West Gables Planning Proposal - Response to Submission - Biodiversity

Eco Logical Australia (ELA) prepared a Biodiversity Certification Assessment Report (v2 dated 6 December 2022) for the West Gables Planning Proposal. The BCAR has been reviewed by The Hills Council. This letter provides a response to the matters raised by Council in their email (M.Munari) dated 22 February 2024.

Figure 1 Vegetation condition

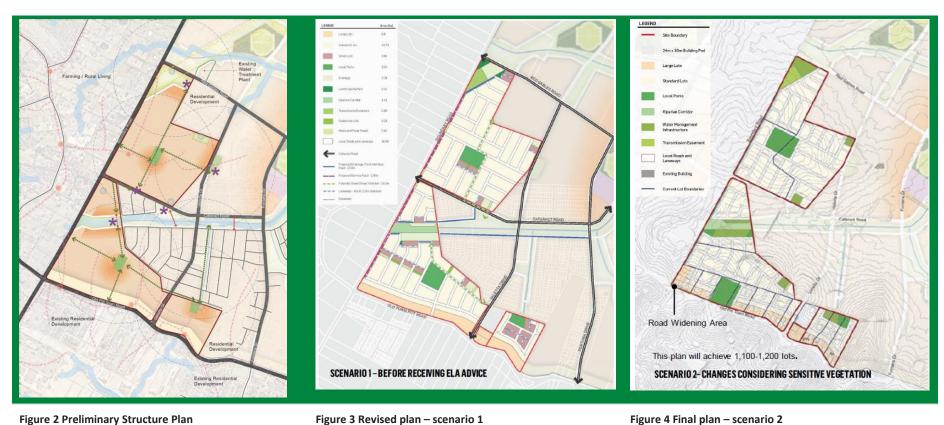
Field survey of Plant Community Types, their condition and their status (eg; endangered, critically endangered) were undertaken in July 2021 and May 2022. The majority of vegetation was mapped as Critically Endangered Ecological Community and therefore is high conservation value, however the vegetation is fragmented and in either low or moderate condition. The figure from the BCAR is provided below (Figure 1). The vegetation on site has little offsite connectivity.

Figure 3 Revised plan – scenario 1

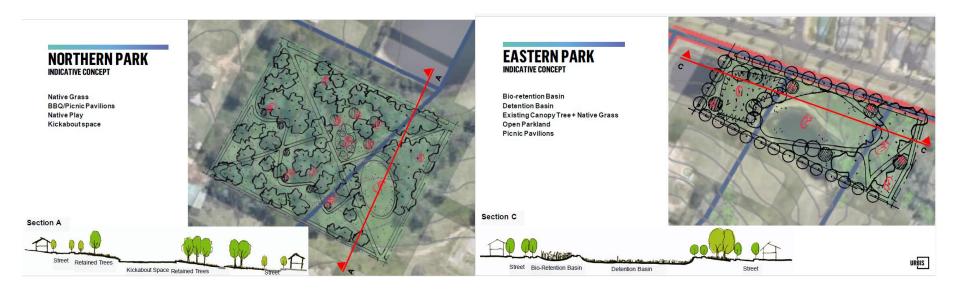
Summary of council matter Response In terms of biodiversity, the location chosen is approximately 80 ha and has approximately 11.1 ha of native vegetation, of which 7.83 ha is native vegetation in low condition, with the remainder in moderate condition. Following supply of the biodiversity values information, re-design of the concept plan was undertaken (see figures 2,3 and 4 below) which: Increased the size of parks and riparian corridor which provided for an avoidance of more native vegetation. The proposal avoids impacts to 4 ha of native vegetation by retaining vegetation in parks. Further justification for the use of 'avoidance' in the parks is provided below. Provided retention of trees in a road buffer (see figure 6 below) Consideration was given to retention of trees in large lots, however Council (M.Munari 11 Oct 2022) advised that trees retained in in private lots would not be counted as protected. The design has focussed retention of native vegetation in the largest patch in the north of the site as well as two other parks. This will be subject to a Vegetation Management Plan and eventual transfer to Council so that the vegetation is in public ownership. Where impacts are proposed to native vegetation, the following mitigation measures are proposed: A Biodiversity Management Plan to ensure removal of habitat minimises harm to native animals Purchase and retirement of biodiversity credits as required by the Noted. The final BCAR will include additional information on prescribed impacts Prescribed impacts such as water quality and hydrology. The BCAR must accurately identify all Noted. Final BCAR to include map of all HBT. hollow bearing trees within the subject

All parks increased in size to enable retention of more vegetation.

Further increase size of all parks to retain more vegetation. Add service road along Boundary Road with retention of trees.

Figure 5 Park concepts

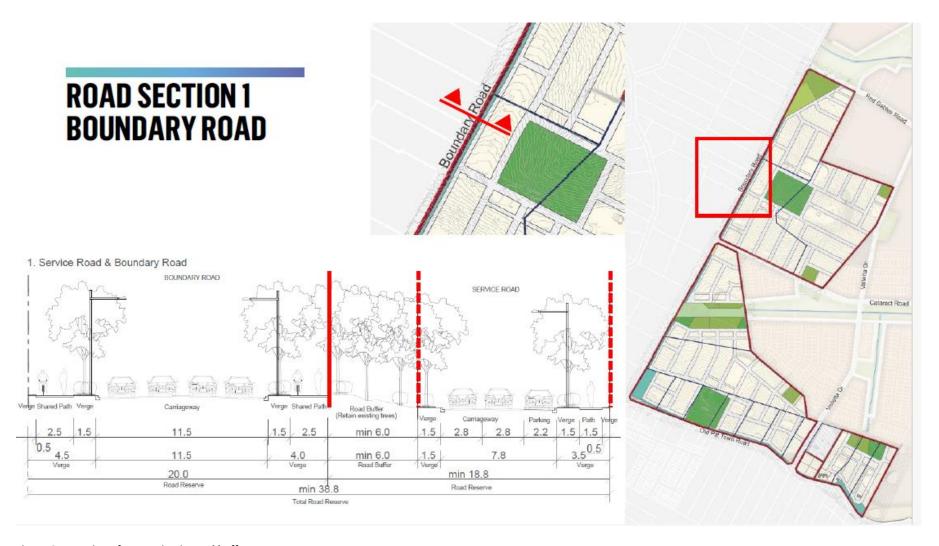
The "Biodiversity Certification Fact Sheet #1: Avoiding and minimising impacts" indicates that "biodiversity values on land that has been avoided when designing areas for development should be protected from future impacts" and as such Council would expect the Proponent to have considered the amount of these 'avoided areas' that are to be protected and those that can contain structures, paths, play equipment etc. This is not evident in the material provided

Detailed design of the parks has not yet been undertaken. However figures below shows indicative concept for the parks. The following principles would apply:

- Locate kick-about spaces and amenities in existing cleared areas. If any native vegetation is proposed to be impacted, it would not be classified as 'avoided'.
- Micro-site footpath locations so that they avoid removal of mature trees. Footpaths should be low impact construction, and have down lighting to minimise light spill.
- Bushfire Asset Protection Zones should not be located within the Park
- A Vegetation Management Plan is to be prepared and implemented for weed removal and rehabilitation of native vegetation.
